UNITED STATES PATENT AND TRADEMARK OFFICE

APPLICATION NO.	FILING DATE	FIRST NAMED INVENTOR	ATTORNEY DOCKET NO.	CONFIRMATION NO.
10/632,449	07/31/2003	Lynn Bich-Quy Le	1229.0001	3797

Office Action Summary	Application No.	Applicant(s)	
	10/632,449	LE ET AL.	
	Examiner	Art Unit	
	Justin Krause	3682

DETAILED ACTION

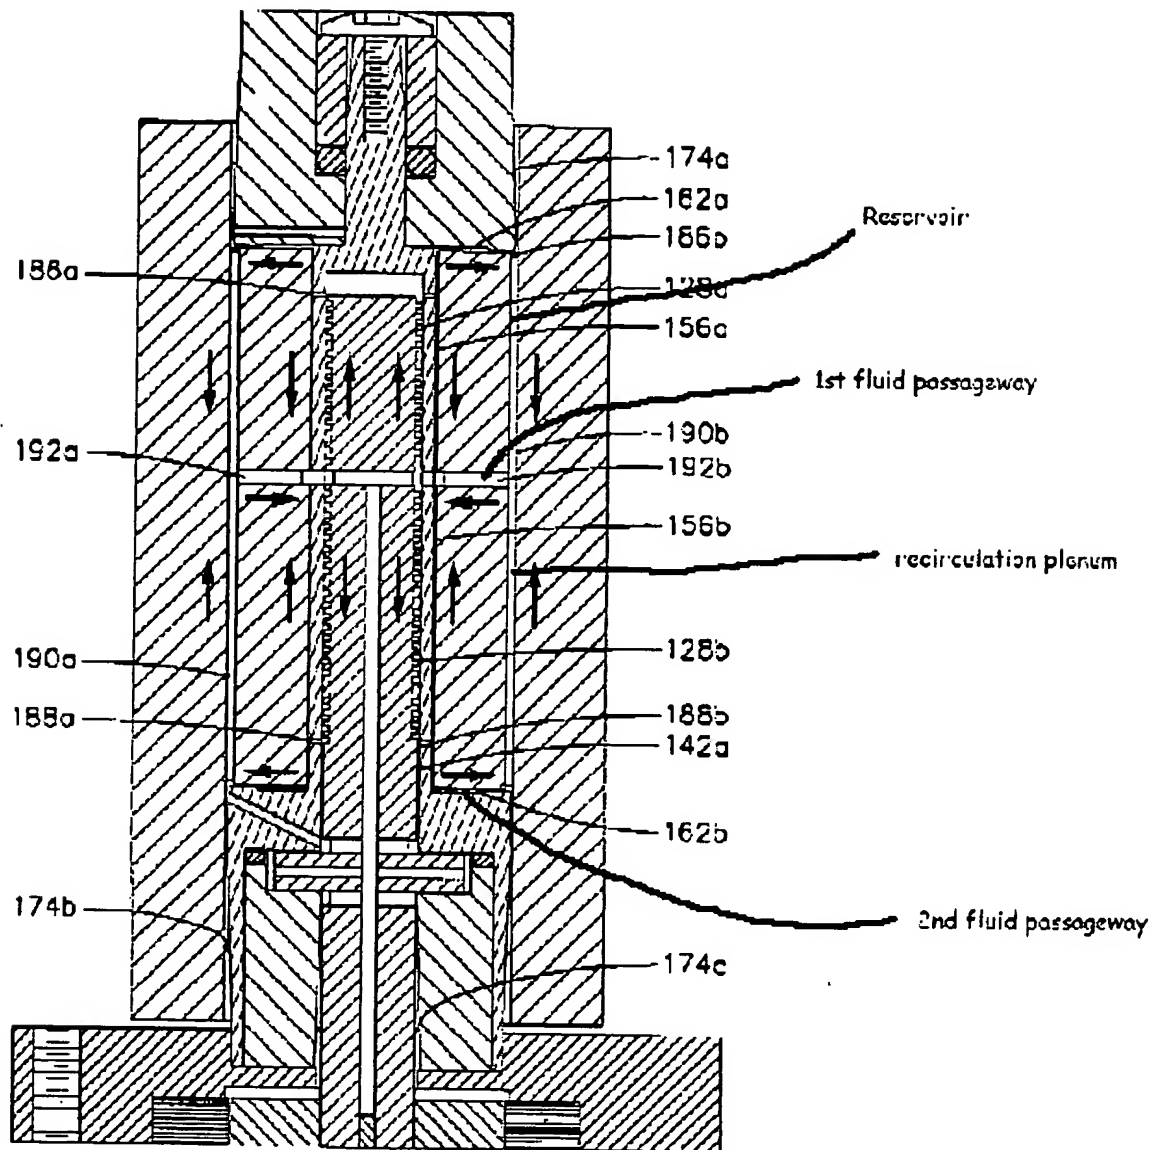
6. Claims 15, 20, 34-36 and 39, as best understood, are rejected under 35 U.S.C. 102(b) as being anticipated by Titcomb (US Patent 6,315,452).

Titcomb discloses a hydrodynamic bearing assembly for use in combination with a spindle motor of a disc drive device comprising:

-a journal (generally 156) defined between an inner component (112) and an outer component (146), which are positioned for relative rotation.

-a fluid recirculation passageway including a first fluid passageway (192) defined within the outer component and in fluid communication with a second fluid passageway (162b), the second fluid passageway defined between the outer component and a radial member (158b) extending radially from the inner component, the first and second passageways in fluid communication with the journal at separate locations,

-a shield (160) affixed to the stationary component, defining a reservoir (190) with the outer component, and a recirculation plenum is defined by a junction joining the reservoir, the first fluid passageway and the second fluid passageway, and means for sealing the reservoir.

Regarding claim 34, the device comprises means for creating an asymmetric pressure gradient within the fluid recirculation passageway (see fig 7), circulating fluid and purging air in the fluid, wherein the fluid substantially circulates about the journal, the first fluid passageway and the second fluid passageway (see figure 3).

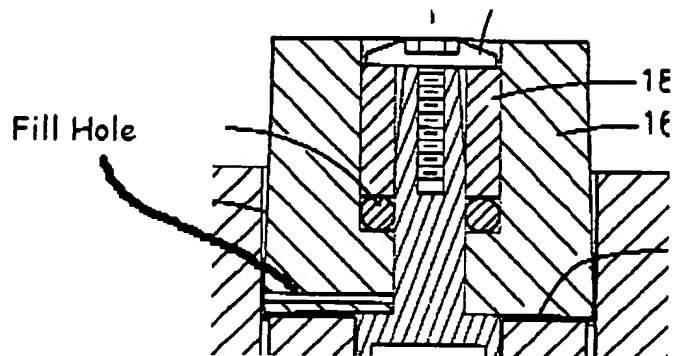
Regarding claim 19, a fill hole (see fig below) is defined within the shield, wherein a meniscus is positioned between the fill hole and the fluid in the reservoir, the fill hole making an angle with the surface of the shield.
